**CITY OF CHARLOTTESVILLE
BOARD OF ARCHITECTURAL REVIEW
STAFF REPORT
May 15, 2018**

BAR 18-05-04

250 West Main Street

Proposed exterior renovations

③ EAST ELEVATION
1/4" = 1'-0"

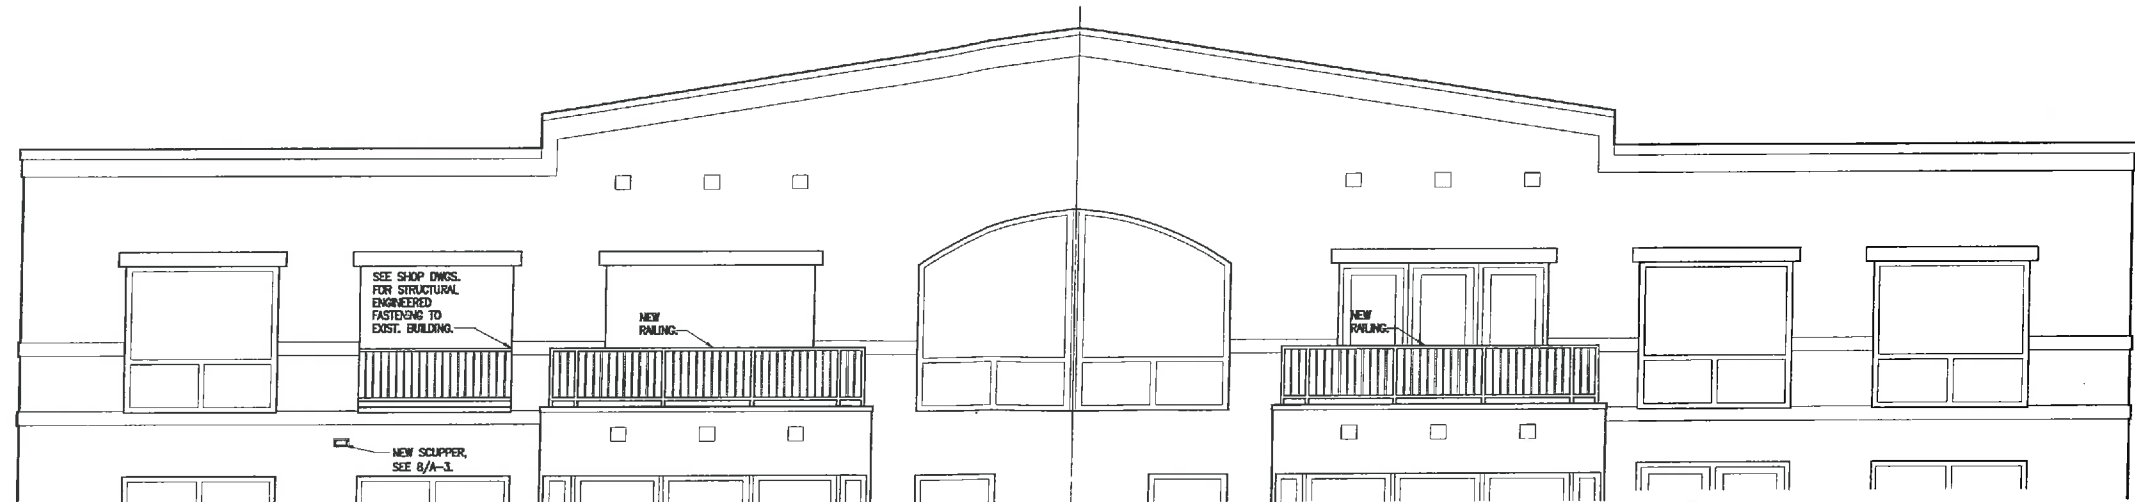
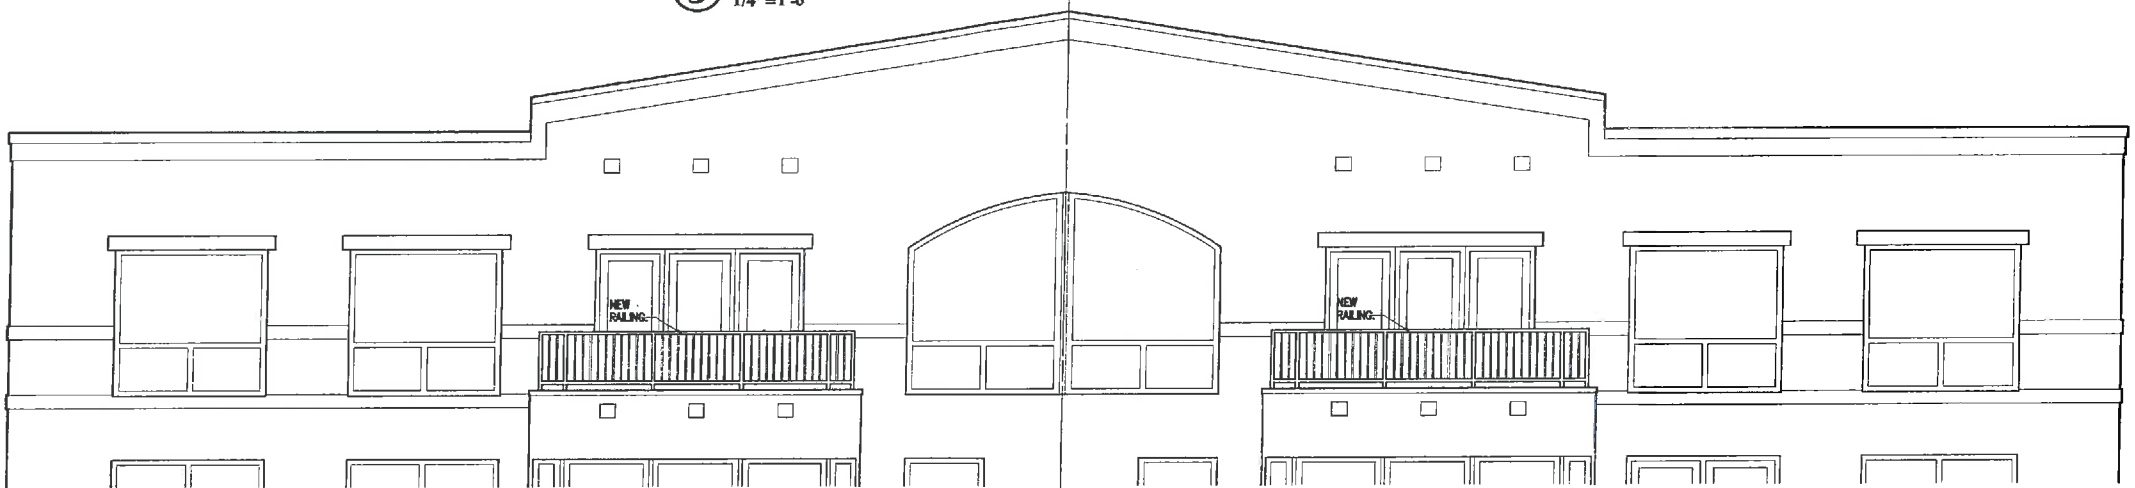
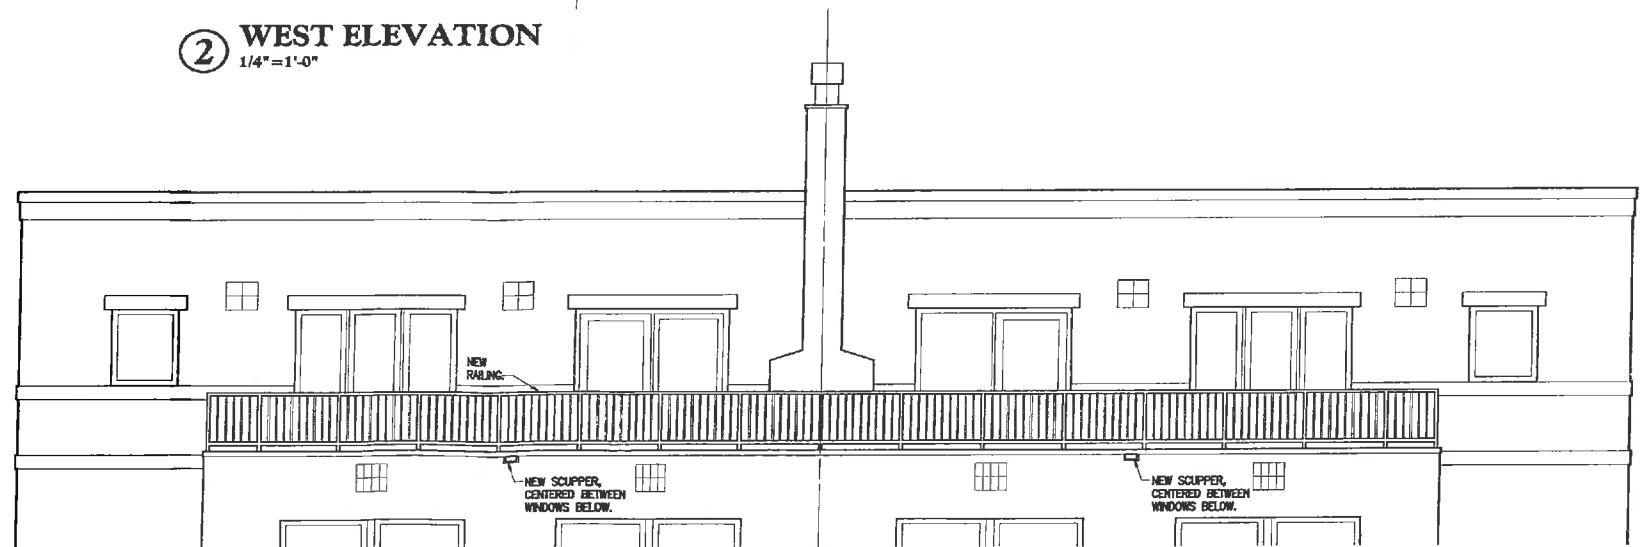
The BAR should clarify that the building's owner does not intend to add new railings. The narrative states that "the building owner has decided not to replace the existing railings with new railings," but the elevation drawing clearly shows new railings. If the owner wishes to replace the current railings, they should specify the material, color, and dimensions of the specified railing.
